**BEFORE THE INDEPENDENT HEARING PANEL
AT GISBORNE**

IN THE MATTER OF resource consent applications by **Gisborne District Council – Rivers and Land Drainage** for the construction and upgrading of approximately 4.2 kilometres of stopbanks, associated earthworks, road raising, drainage and stormwater infrastructure, works within and adjacent to the Waipaoa River, temporary water take and discharge activities during construction, vegetation clearance, temporary access works, service relocations, and landscape planting and site reinstatement, referred to as the Te Karaka Stopbank Flood Protection Scheme upgrade.

**STATEMENT OF CHRISTOPHER STEWART COATES –
ON BEHALF OF THE JRD AND PA COATES FAMILY TRUST AND COATES FAMILY**

27th SEPTEMBER 2026

Annexure A – The Property Group, Coates Property Flood Depth Plan, JO-26-00360, 19 August 2026 (existing vs proposed, design event)

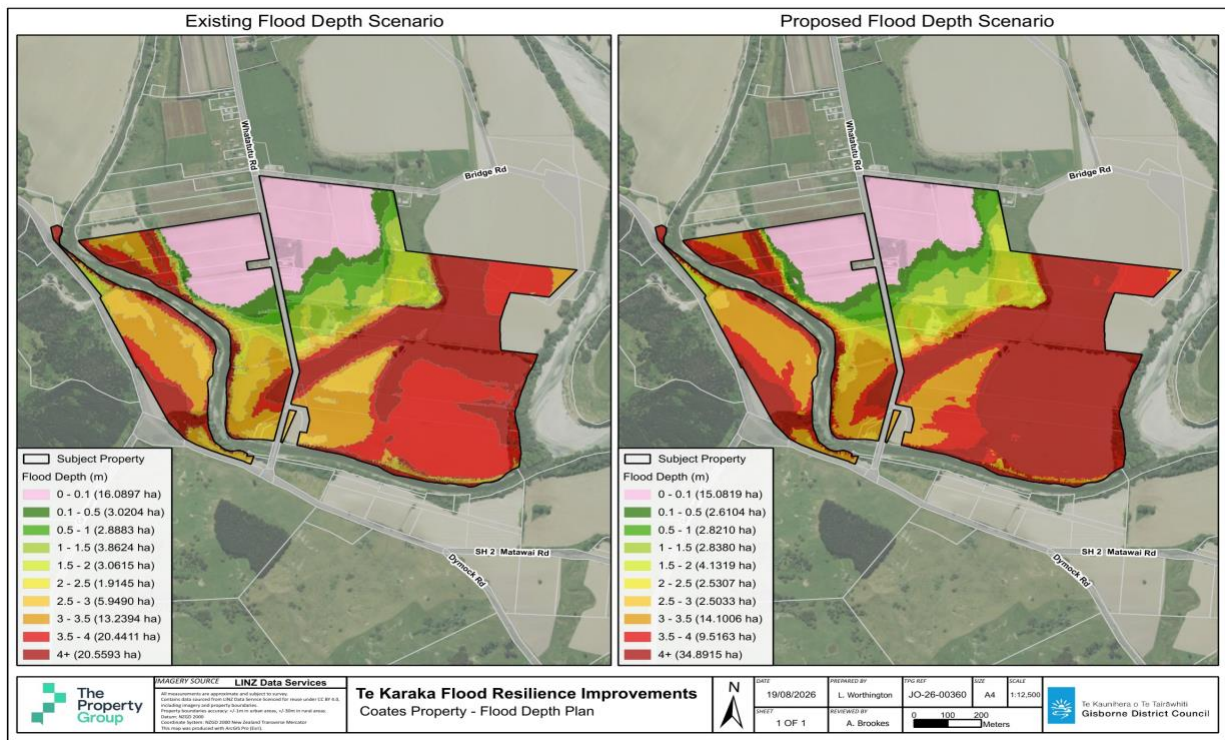
my brother made three attempts to reach our father, and where he recovered his body. This property was catastrophically affected, and in my view, the assessment does not adequately reflect the scale of the effects experienced on the farm. Council's own depth map compares the Farm under the existing scheme with the Farm under the Proposal, in the design event. Four metres of water is above the roofline of a single-storey house. Under the Proposal, nearly 40 per cent of the Farm is under that depth, and almost two-thirds of the Farm is under more than 3 metres.⁵

Annexure B – The Property Group, Coates Property Flood Hazard Plan, JO-26-00360, 19 August 2026 (existing vs proposed, design event)

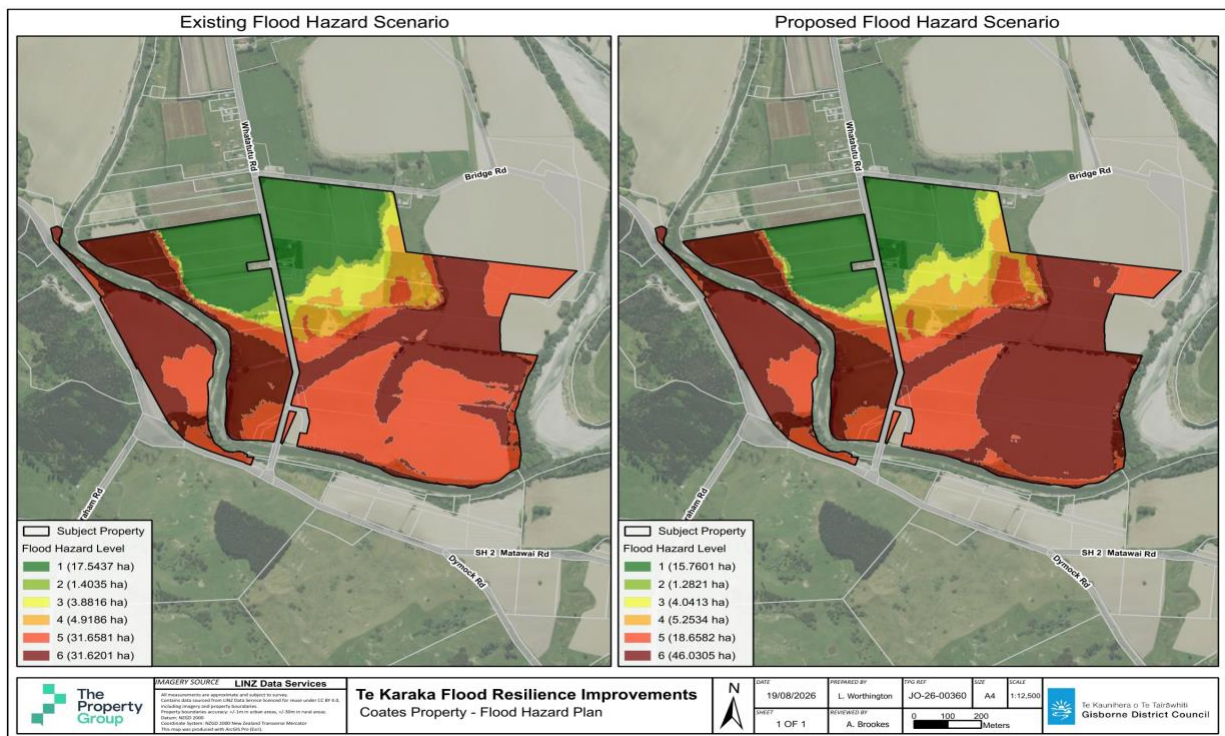
22. **The hazard rating for the Farm goes up.** Council's own flooding witness says "significant parts of the property experience an increase of one hazard class in the design event",⁶ and Council's planner accepts that the Project "pushes water" onto submitters' land.⁷ Council's own hazard map shows what that means: under the existing scheme about a third of the Farm is in the highest hazard class, H6; under the Proposal it is half, with 13 hectares moving from H5 to H6 and the small area of safe ground shrinking further. Over three-quarters of the Farm is already at H4 or worse.⁸ The assessment does not go on to say what that means for the people, stock and business on the Farm.

Annexure C – Waipaoa River cross-sections 30.5–41, bed and berm aggradation 1950s–2017/18, plotted from the GDC river cross-section archive (2013 benchmark datum). Record ends Jan 2017/18; no post-Gabrielle surveys.

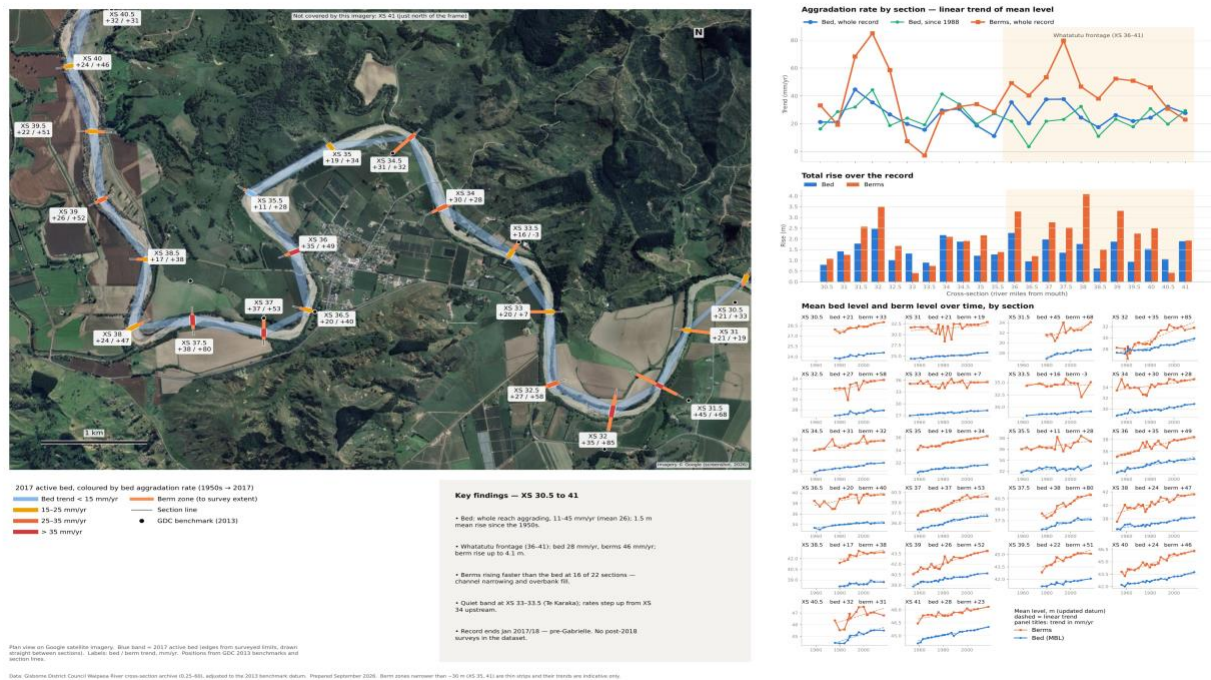
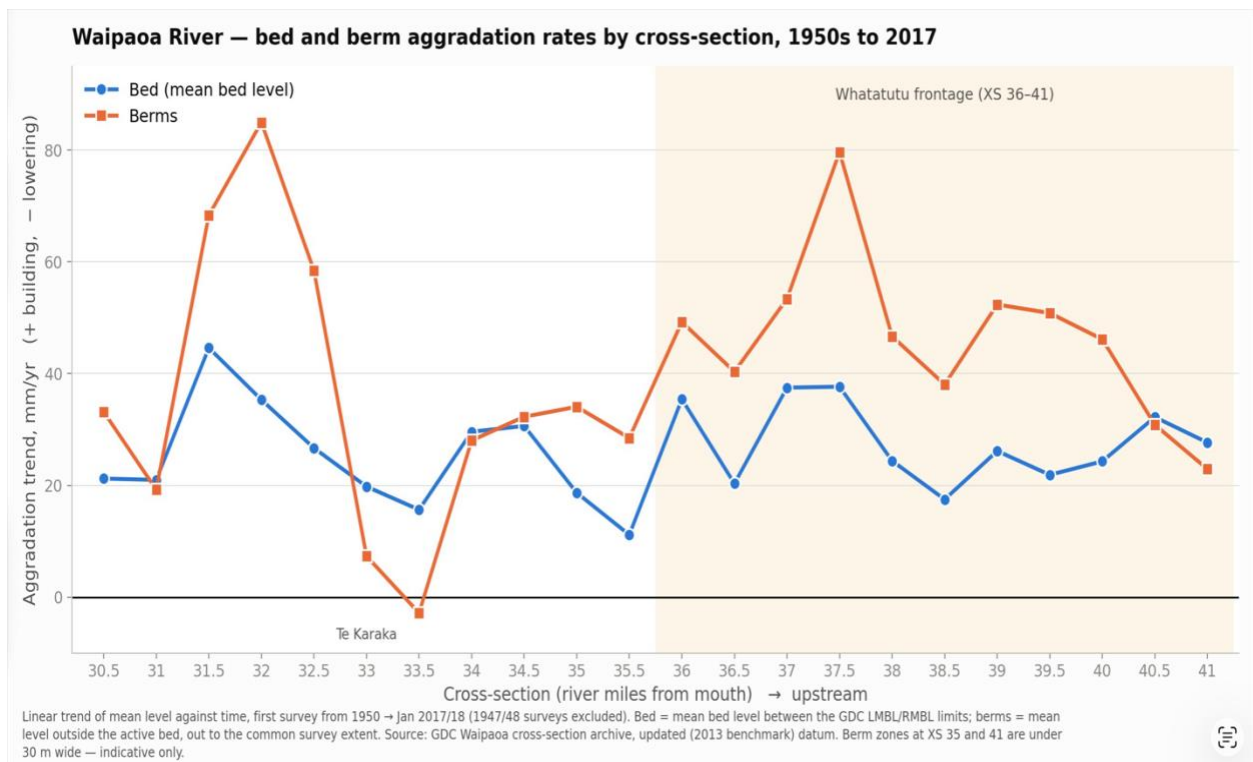
every section, 11 to 45 millimetres a year, averaging 26 – about 1.5 metres since the 1950s.¹⁶ Along the Farm’s frontage (cross-sections 36 to 41) the bed has risen at 28 millimetres a year and the berms at 46, with berm rise of up to 4.1 metres. The berms are rising faster than the bed at 16 of 22 sections: the channel is narrowing and the floodplain is filling. The Te Karaka sections are the quiet part of the reach; the rates step up from cross-section 34 upstream, which is our end. The record ends before Gabrielle, which Tonkin + Taylor’s own geomorphic assessment says raised the active channel by about half a metre, with heavy deposition on the true right floodplain – our side.¹⁷

28. So overall, the Council’s own record at the farm shows a bed rate double the 14 millimetres the Proposal relies on, and a berm rate more than three times it. Tonkin + Taylor accept that aggradation at Te Karaka “is expected to persist for decades”, that repeated deposition “must be expected”, and that the lowest-risk long-term strategy “may ultimately be a managed retreat”.¹⁸ Yet the 310 millimetres of extra flooding forecast for the farm is measured against the static 2023 bed only. We want to know what the effect on the Farm will be at the start, middle and end of the scheme’s life, not just at the time the modelling is done, years before the scheme is even built.
